CONTROL CABLE ANCHOR PIN

HARLEY-DAVIDSON MOTOR CO.

Handlever Control Cable Assembly
Viewed from Ball End of Lever

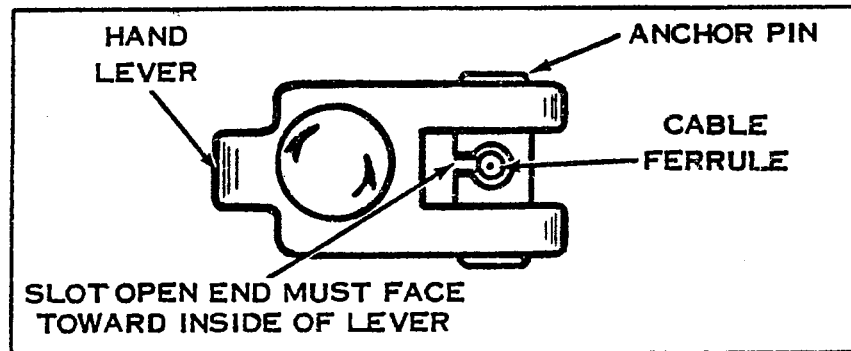
1968 Electra Glide and Sportster models have a new type clutch and brake control cable anchor pin located in the hand lever.

The notch for inserting the cable is in the side of the new type anchor pin instead of at the bottom as in older type pins.

It is very important that the open end of the notch is located toward the inside (closed end) of the hand lever when the cable is installed. Correct installation is shown in the illustration below.

If the cable is installed with the open side of the notch toward the outside (open end) of the hand lever, the cable ferrule could conceivably become disengaged from the hand lever and result in loss of front brake or clutch control.

Controls have been assembled correctly on all motorcycles shipped from the factory. When controls with the new type pin are disassembled for service, be sure they are reassembled correctly.
